SUBJECT: MCGUIRE NUCLEAR STATION, UNITS 1 AND 2 RE: ISSUANCE OF
AMENDMENTS (TAC NOS. MA9730 AND MA9731)

The amendments revise TS Section 3.7.15 and associated Bases, and Section 4.0 of the McGuire Nuclear Stations, Units 1 and 2, licenses to allow the use of credit for soluble boron in spent fuel pool criticality analyses. The request is based on the NRC-approved Westinghouse Owners Group Topical Report WCAP-14416-NP-A, which provides generic methodology for crediting soluble boron. The review has included the evaluation of the criticality aspects, Boraflex degradation, and boron dilution event analysis. The staff's approval is contingent on completion of the proposed Boraflex verification testing in Updated Final Safety Analysis Report Section 16.9-9, "Spent Fuel Pool Storage Rack Poison Material."

Amendment No. 197
License No. NPF-9

Amendment No. 178
License No. NPF-17

Figure 3.7.15-1 (page 1 of 1)
Required 3 out of 4 Loading Pattern for Restricted Region 1A Storage

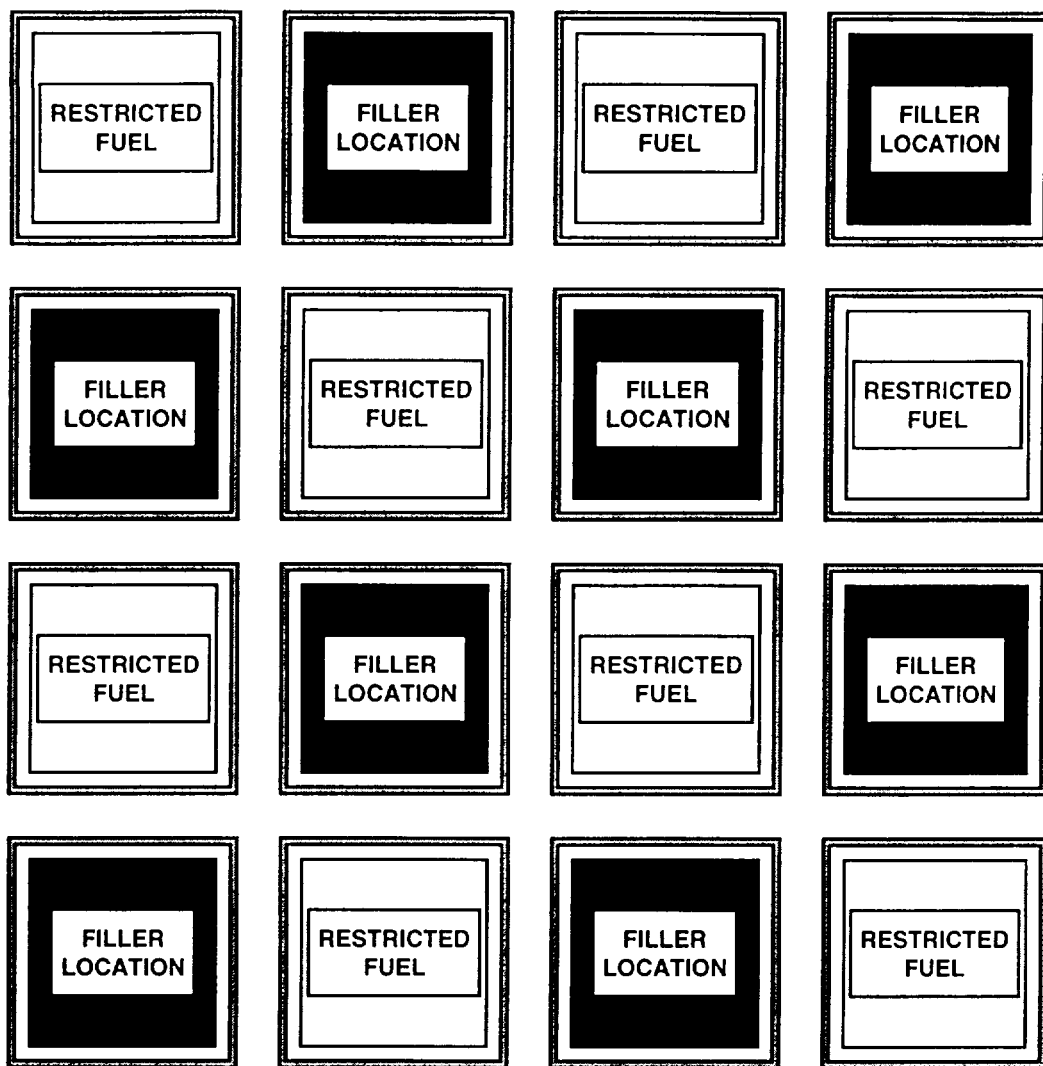
- 2. Unrestricted storage of fuel meeting the criteria of Table 3.7.15-2; or
 - 3. Restricted storage in accordance with Figure 3.7.15-1, of fuel which does not meet the criteria of Table 3.7.15-1 or Table 3.7.15-2.

Restricted storage configurations must be employed for assemblies that do not qualify for unrestricted storage. A calculation was done for Region 1A assuming a 3-out-of-4 assembly storage configuration with three fresh assemblies and a fourth low-reactivity filler assembly. This loading pattern is shown in proposed TS Figure 3.7.15-1. The nominal enrichment of the fresh fuel required to maintain k_{eff} less than 1.0 for this configuration and no soluble boron was found to be 4.75 w/o U-235. The maximum allowed enrichment of the filler assembly was 1.76 w/o U-235.

Boundary Condition: Any Restricted Region 1A Storage Area row bounded by any other storage area shall contain a combination of restricted fuel assemblies and filler locations arranged such that no restricted fuel assemblies are adjacent to each other. Example: In the figure above, row 1 or column 1 can not be adjacent to another storage area, but row 4 or column 4 can be.

Figure 3.7.15-2 (page 1 of 1)
Required 2 out of 4 Loading Pattern for Restricted Region 1B Storage

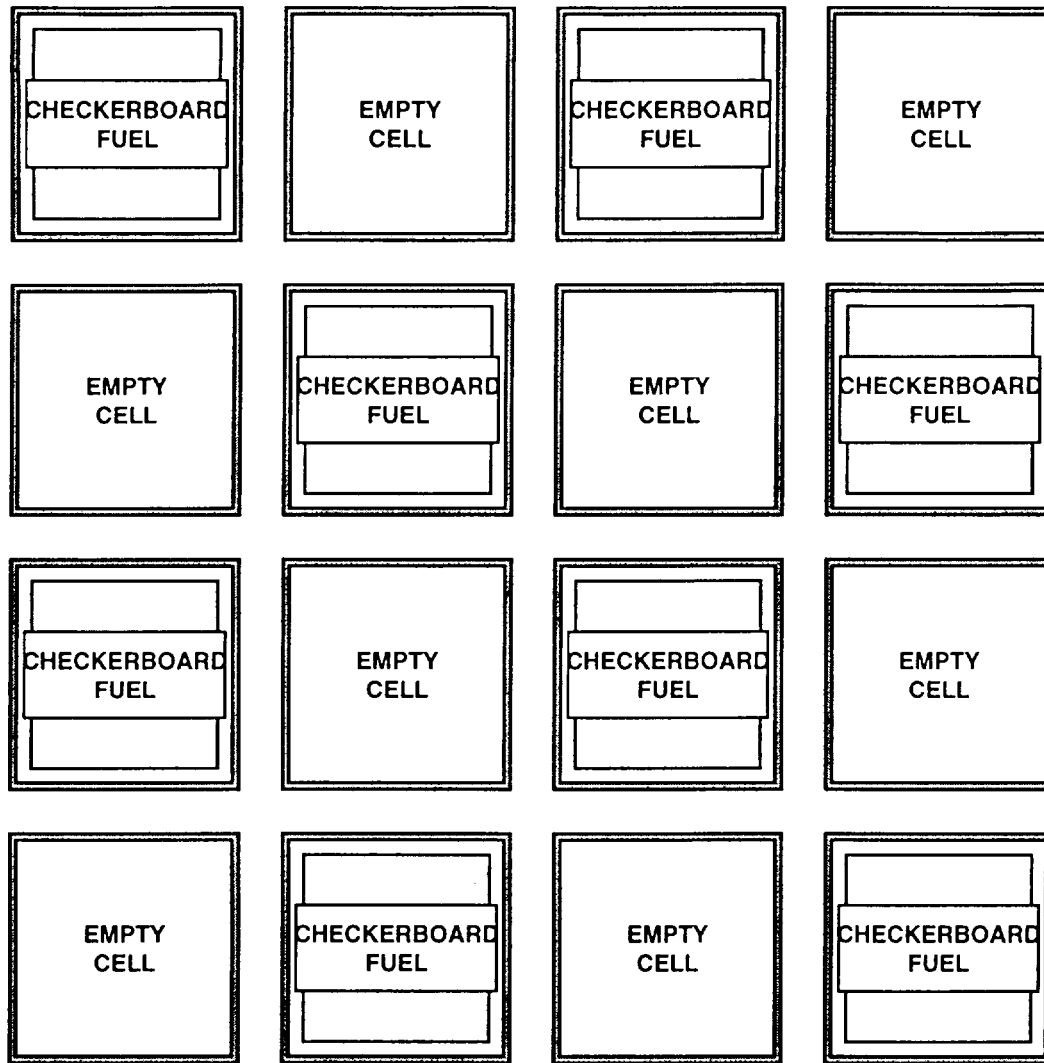
- 2. Restricted storage in accordance with Figure 3.7.15-2, of fuel which meets the criteria of Table 3.7.15-5; or
 - 3. Checkerboard storage in accordance with Figure 3.7.15-3 of fuel which does not meet the criteria of Table 3.7.15-5.

Restricted storage configurations for Region 1B resulted in a 2-out-of-4 pattern with two 2.20 w/o assemblies and two 1.44 w/o filler assemblies, as shown in proposed TS Figure 3.7.15-2. Restricted storage configurations for Region 2A also resulted in a 2-out-of-4 pattern with two 2.12 w/o assemblies and two 1.20 w/o assemblies, as shown in proposed TS Figure 3.7.15-4. Restricted storage configurations for Region 2B resulted in a 1-out-of-4 pattern with one 1.22 w/o assembly and three 1.08 w/o assemblies, as shown in proposed TS Figure 3.7.15-6.

Figure 3.7.15-3 (page 1 of 1)
Required 2 out of 4 Loading Pattern for Checkerboard Region 1B Storage

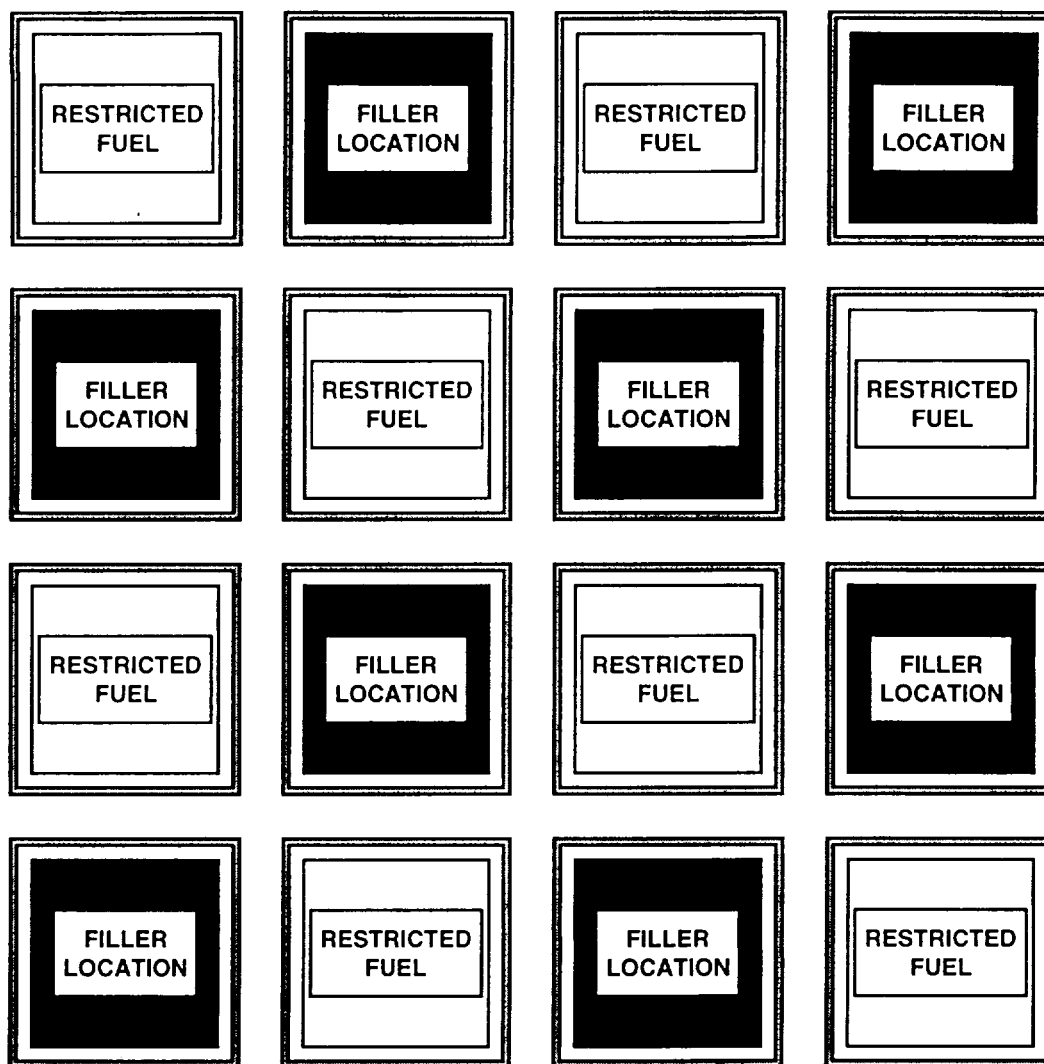
The restrictions on the placement of fuel assemblies within the Region 1B of the spent fuel pool, which have accumulated burnup greater than or equal to the minimum qualified burnups in Table 3.7.15-4 in the accompanying LCO, ensures the k_{eff} of the spent fuel pool will always remain ≤ 0.95 , assuming the pool to be flooded with water borated to 730 ppm. Fuel assemblies not meeting the criteria of Table 3.7.15-4 shall be stored in accordance with either Figure 3.7.15-2 and Table 3.7.15-5 for Restricted storage, or Figure 3.7.15-3 for Checkerboard storage.

Figure 3.7.15-4 (page 1 of 1)
Required 2 out of 4 Loading Pattern for Restricted Region 2A Storage

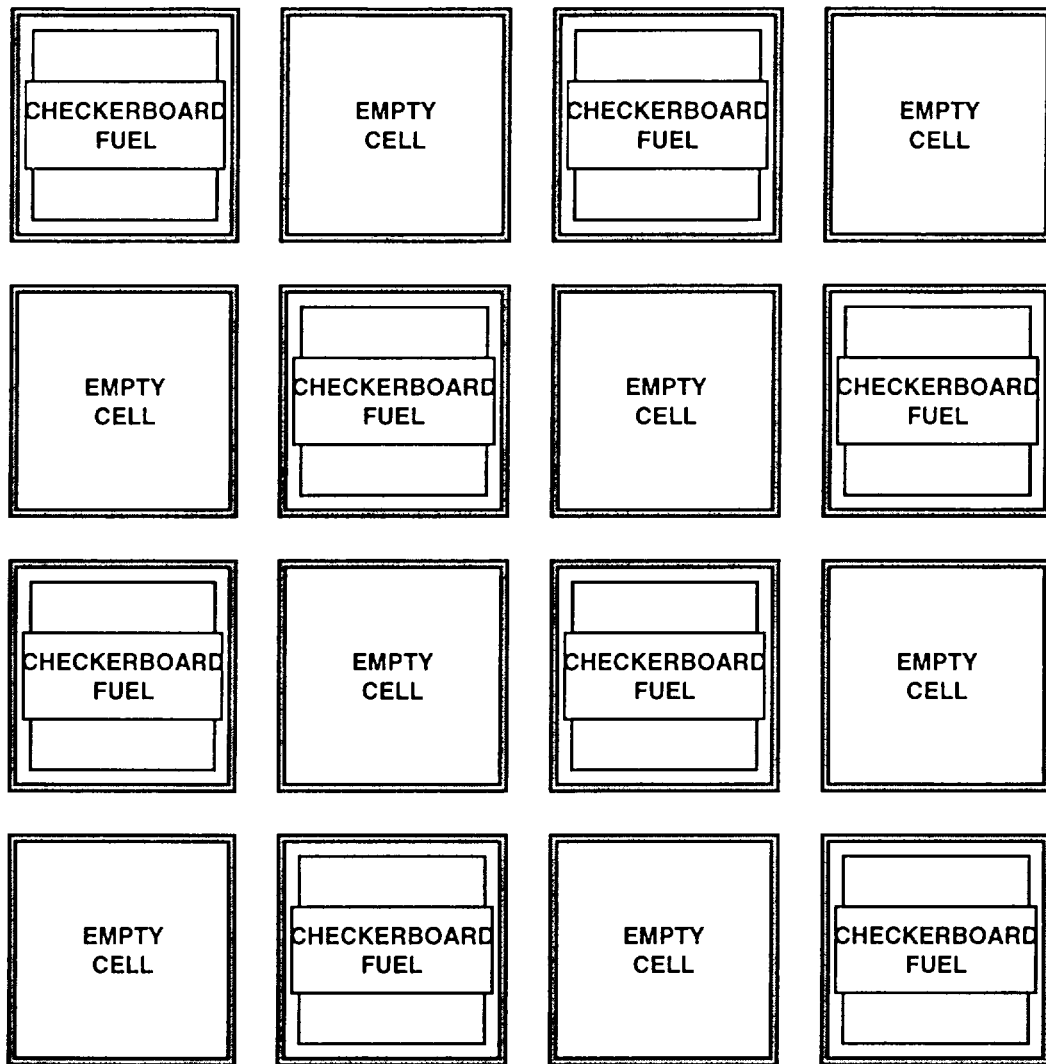
- 2. Restricted storage in accordance with Figure 3.7.15-4, of fuel which meets the criteria of Table 3.7.15-8; or
 - 3. Checkerboard storage in accordance with Figure 3.7.15-5 of fuel which does not meet the criteria of Table 3.7.15-8.

Figure 3.7.15-5 (page 1 of 1)
Required 2 out of 4 Loading Pattern for Checkerboard Region 2A Storage

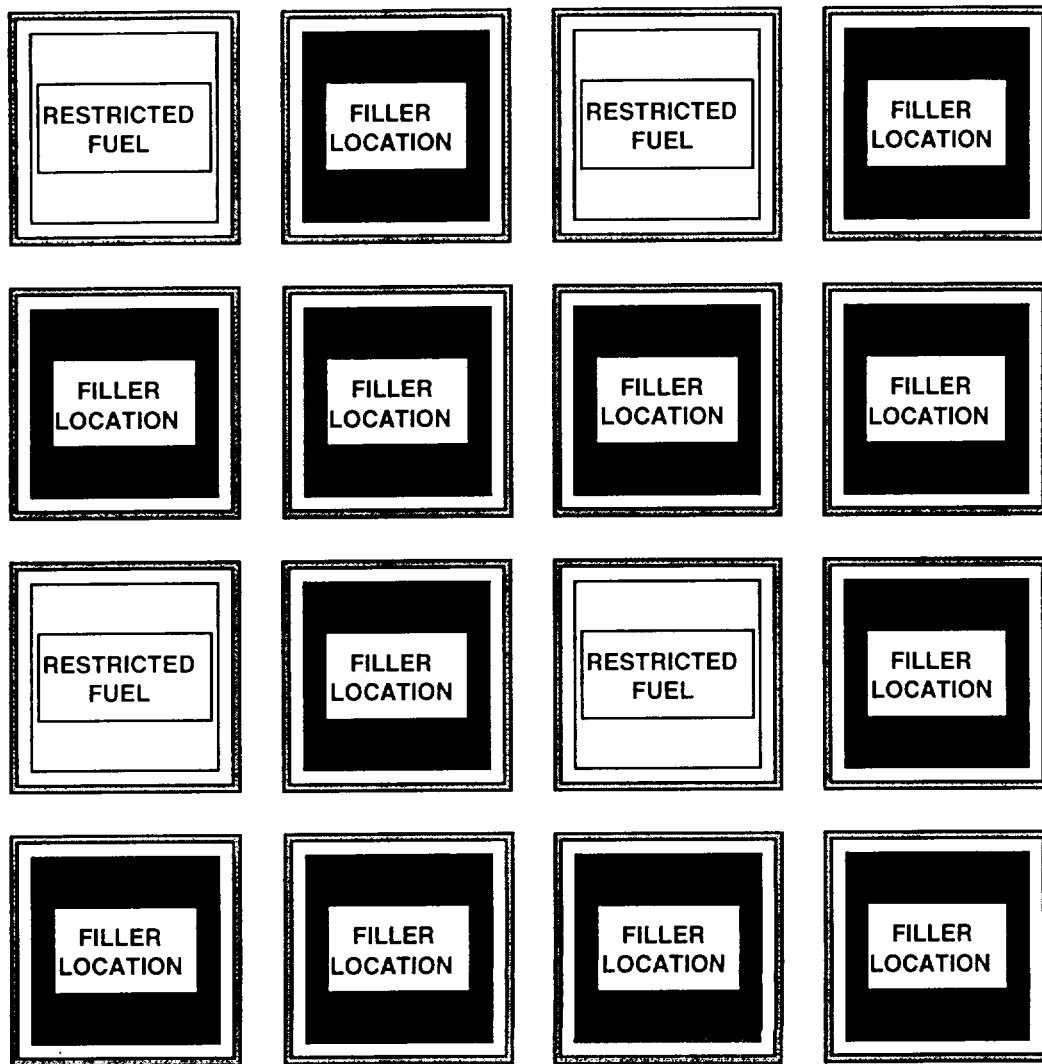
The restrictions on the placement of fuel assemblies within the Region 2A of the spent fuel pool, which have accumulated burnup greater than or equal to the minimum qualified burnups in Table 3.7.15-7 in the accompanying LCO, ensures the k_{eff} of the spent fuel pool will always remain ≤ 0.95 , assuming the pool to be flooded with water borated to 730 ppm. Fuel assemblies not meeting the criteria of Table 3.7.15-7 shall be stored in accordance with either Figure 3.7.15-4 and Table 3.7.15-8 for Restricted storage, or Figure 3.7.15-5 for Checkerboard storage.

Figure 3.7.15-6 (page 1 of 1)
Required 1 out of 4 Loading Pattern for Restricted Region 2B Storage

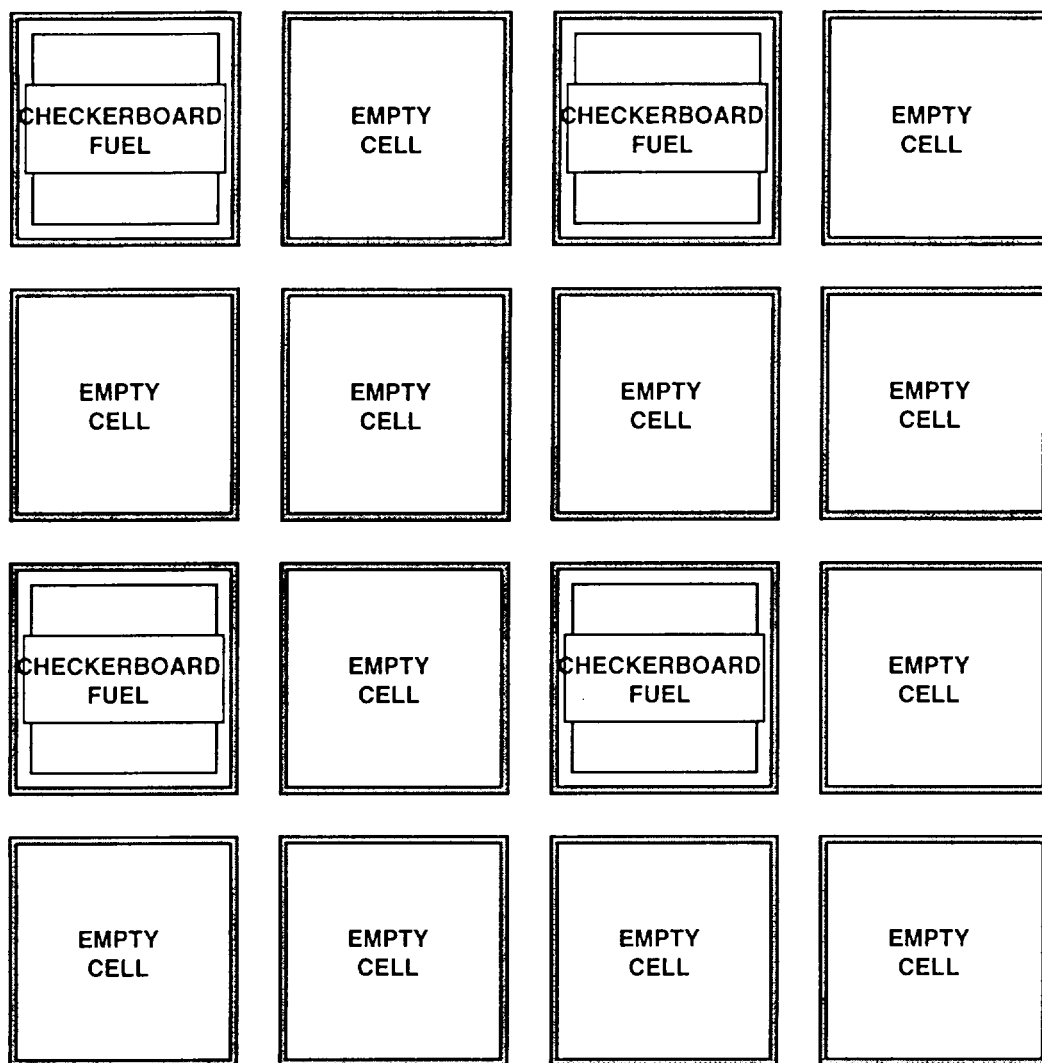
- d. New or irradiated fuel which has decayed at least 16 days may be stored in Region 2B of the spent fuel pool in accordance with these limits:
1. Unrestricted storage of fuel meeting the criteria of Table 3.7.15-10; or
 2. Restricted storage in accordance with Figure 3.7.15-6, of fuel which meets the criteria of Table 3.7.15-11; or
 3. Checkerboard storage in accordance with Figure 3.7.15-7 of fuel which does not meet the criteria of Table 3.7.15-11.

In order to prevent an undesirable increase in reactivity, the boundaries between the different storage configurations were analyzed. The results of this analysis show that (1) any restricted Region 1A storage area row bounded by any other storage area must contain a combination of restricted fuel assemblies and filler locations arranged such that no restricted fuel assemblies are adjacent to each other, (2) any restricted Region 2B storage area row bounded by any other storage area must contain only filler locations arranged such that no restricted fuel assemblies are adjacent to any other fuel except Region 2B filler locations, and (3) any checkerboard Region 2B storage area row bounded by any other storage area must contain only empty cells arranged such that no checkerboard fuel assemblies are adjacent to any fuel. These interface restrictions are shown in TS Figures 3.7.15-1, 3.7.15-6, and 3.7.15-7, respectively.

- Restricted Fuel:** Fuel which meets the minimum burnup requirements of Table 3.7.15-11, or non-fuel components, or an empty location.
- Filler Location:** Either fuel which meets the minimum burnup requirements of Table 3.7.15-12, or an empty cell.
- Boundary Condition:** Any Restricted Region 2B Storage Area row bounded by any other storage area shall contain only filler locations arranged such that no Restricted Fuel assemblies are adjacent to any other fuel except Region 2B Filler Locations. Example: In the figure above, row 1 or column 1 can not be adjacent to another storage area, but row 4 or column 4 can be.
